# **ANCLOTE HARBOR**

## **#20-106 [PRELIMINARY PLANNED DEVELOPMENT]**

**CITY OF TARPON SPRINGS**  
**PLANNING & ZONING BOARD / BOARD OF COMMISSIONERS**  
**November 16, 2020 / December 8, 2020 & December 15, 2020**

**Application No.** 20-106 Preliminary Planned Development  
20-107 Rezoning  
20-123 Conditional Use

Figure 2  
Project Traffic Distribution  
Ancote Harbor Development  
Tarpon Springs, Florida

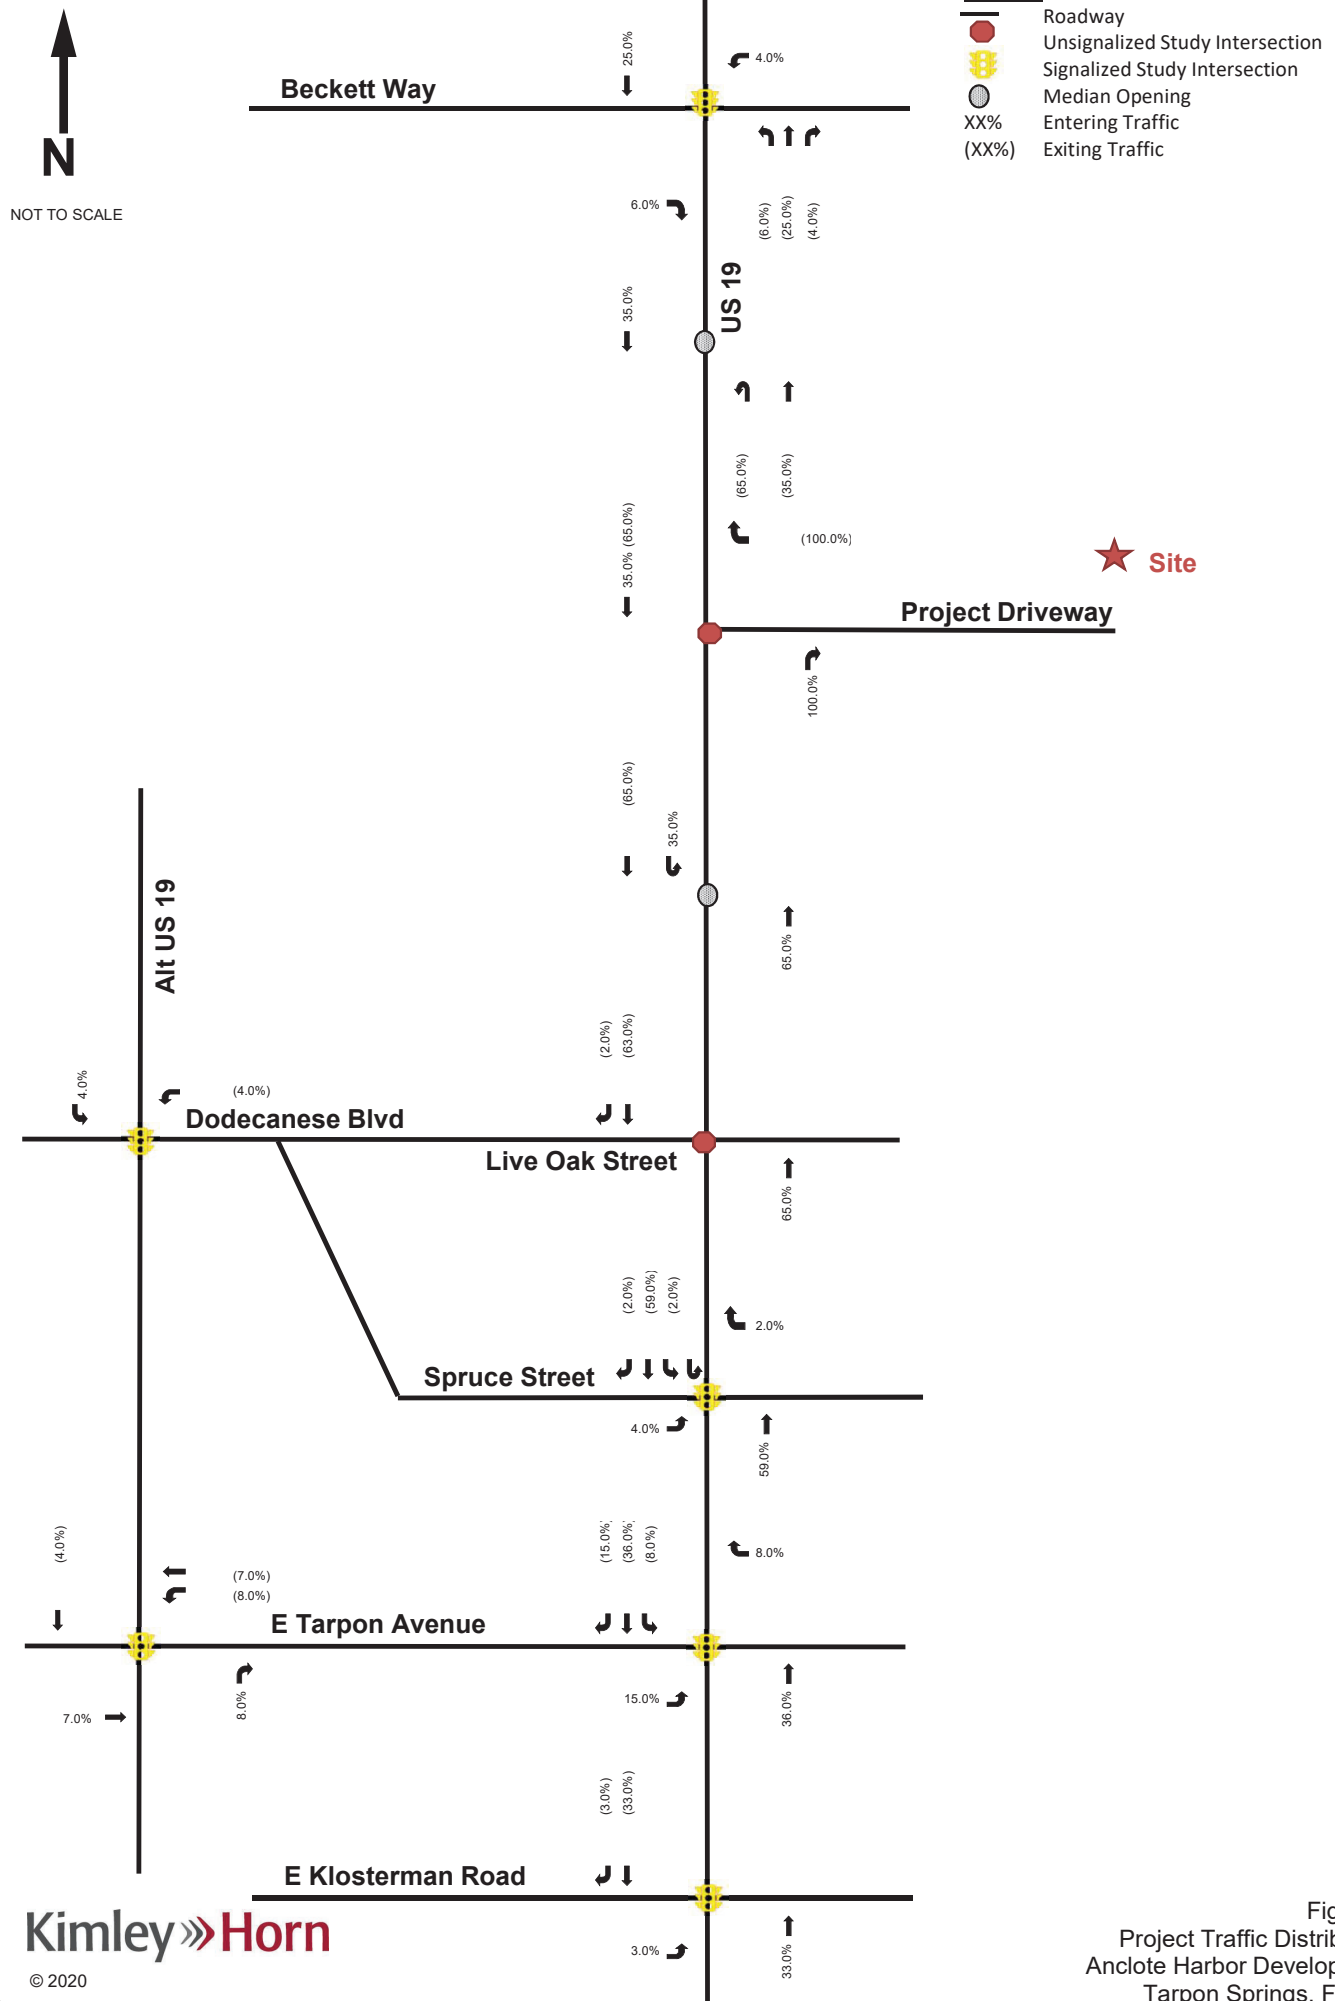
**Comment 5:** Comments on Figure 2,

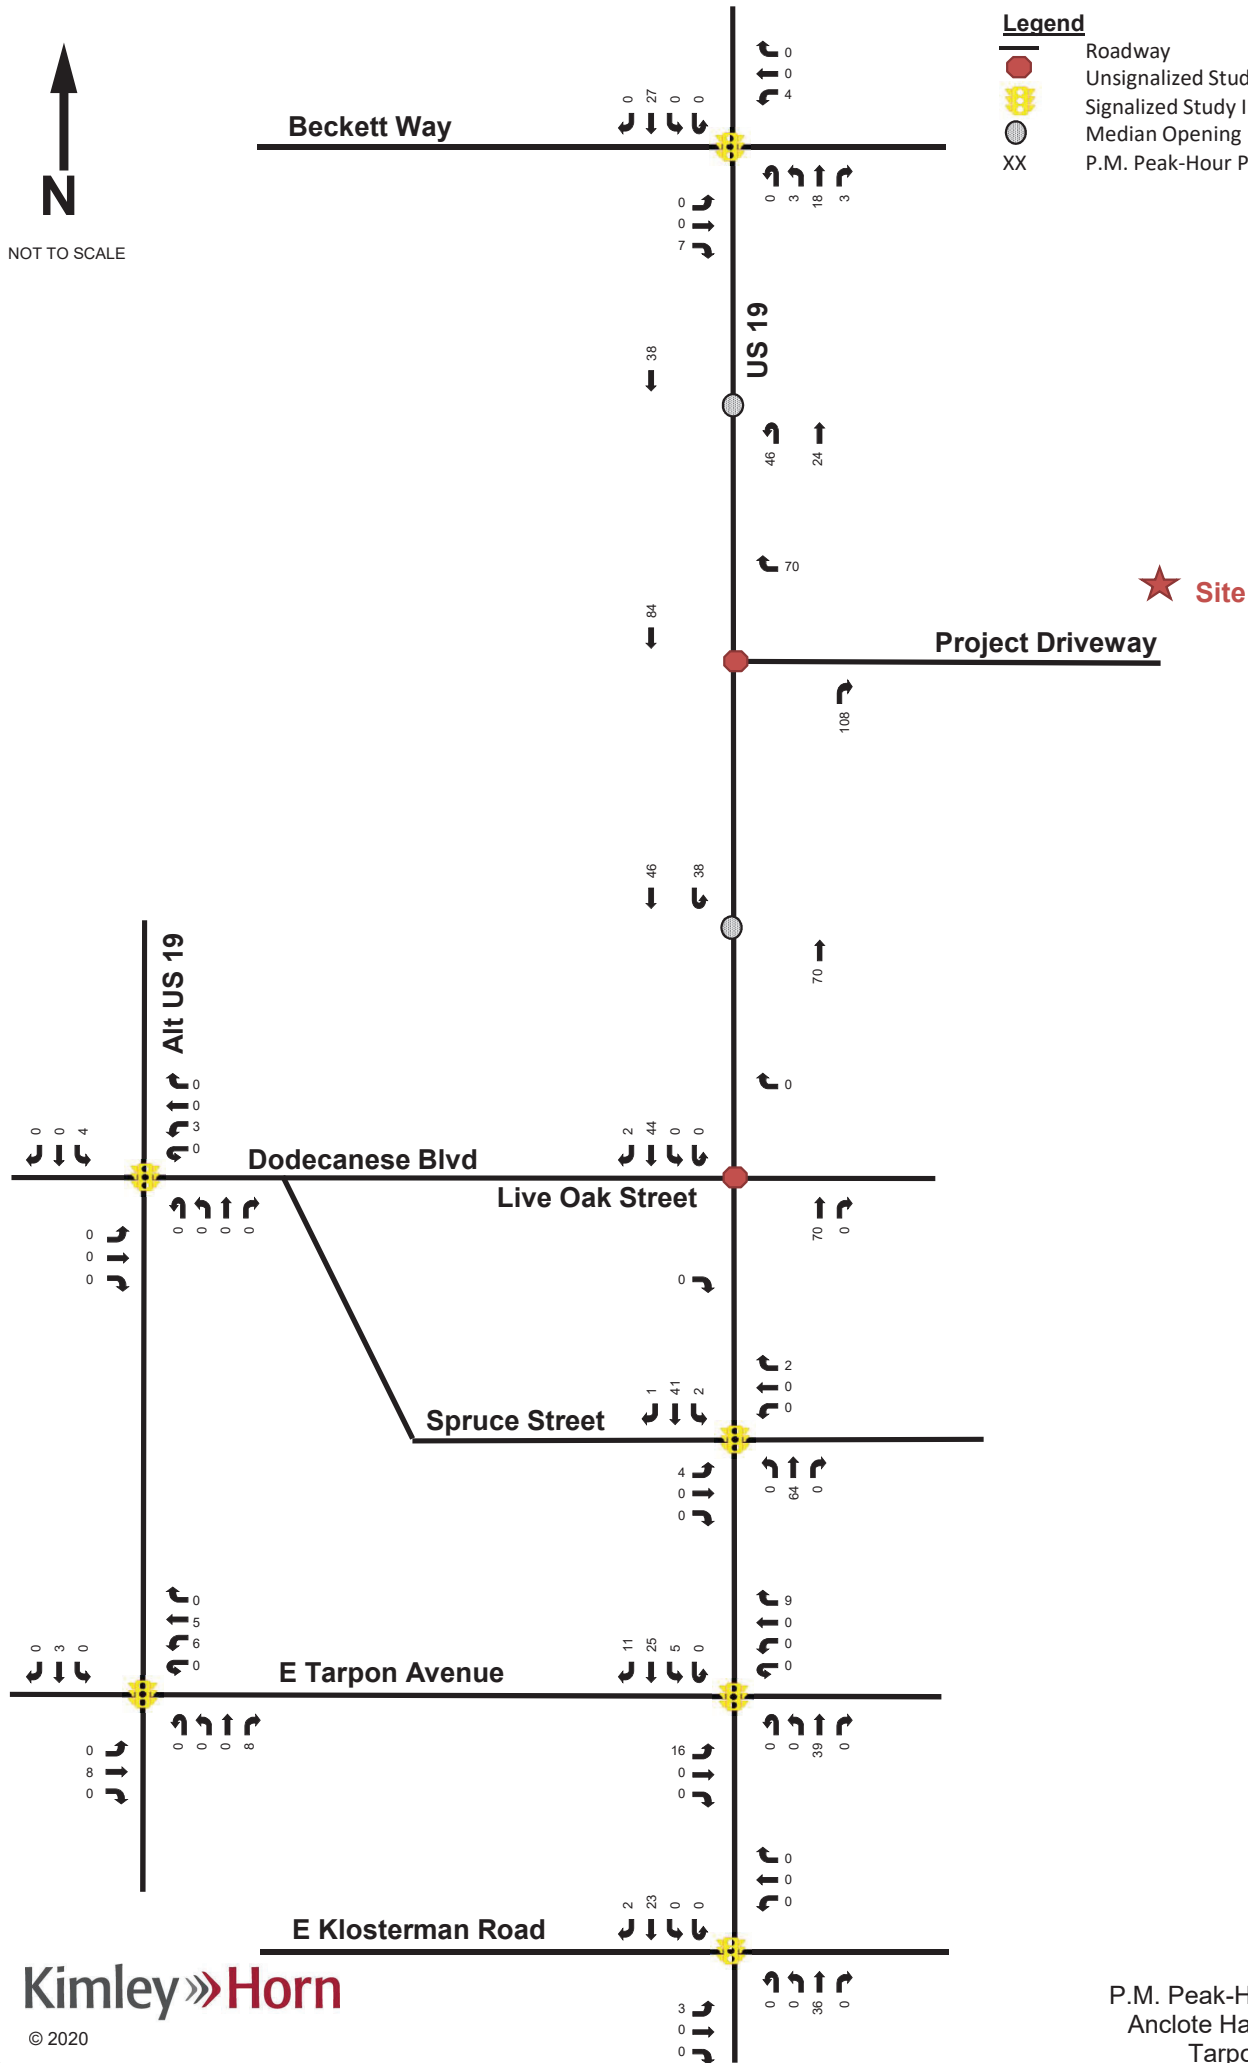
**Comment 7:** Comments on Figure 4,

- a. Traffic volumes from Beckett Way/US 19 Intersection add up to 37 vehicles for SB direction. Figure 4 shows 38 vehicles. Please confirm.
- b. The traffic volumes do not add up the driveway volumes which is 70 vehicles. Please confirm.

- c. Traffic volumes for SB approach at Live Oak St/US 19 Intersection show 45 vehicles for SB direction, whereas upstream it is 46 vehicles per Figure 4. Please confirm.

- d. See previous comment on Traffic Distribution Figure. The traffic assignment on Figure 4, at the Live Oak St/Dodecanese Blvd does not add up at the adjacent intersections of Live Oak St/US 19 and Spruce St/US 19. Also there is traffic volumes along N-S Direction, where are they leading to? Please confirm.

- e. Traffic volumes for SB approach at Live Oak St/US 19 Intersection show 44 vehicles for SB direction, whereas downstream at Spruce St., it is 45 vehicles per Figure 4. Please confirm.

- f. Traffic volumes for SB approach at Spruce St/US 19 Intersection show 41 vehicles for SB direction, whereas downstream at E Tarpon Ave., it is 42 vehicles per Figure 4. Please confirm.

Figure 10  
A.M. Peak-Hour Total Traffic  
Anclote Harbor Development  
Tarpon Springs, Florida

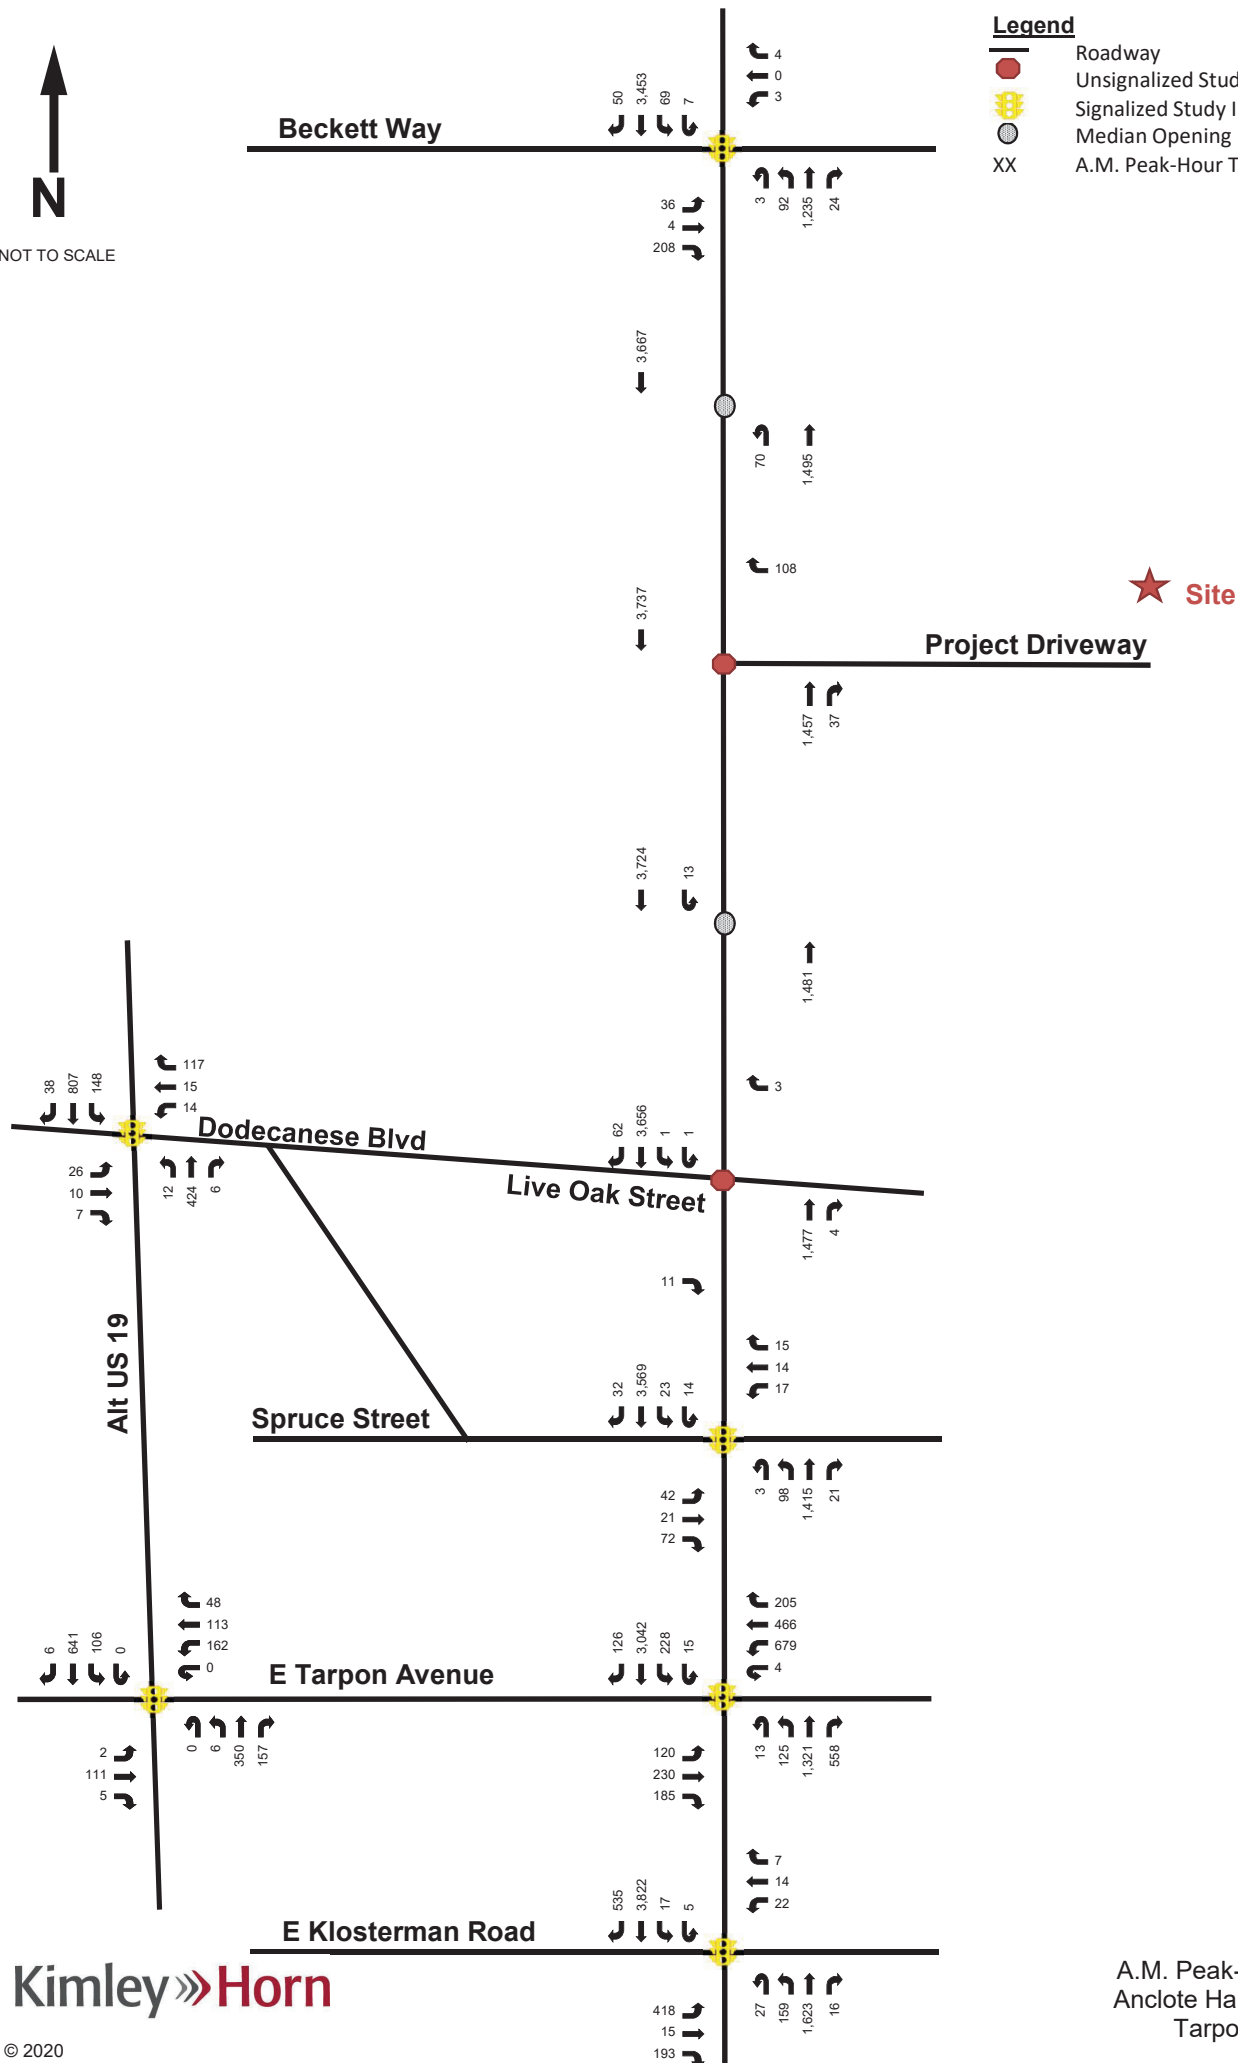
**Comment 10:** Comments on Figure 10, 11-
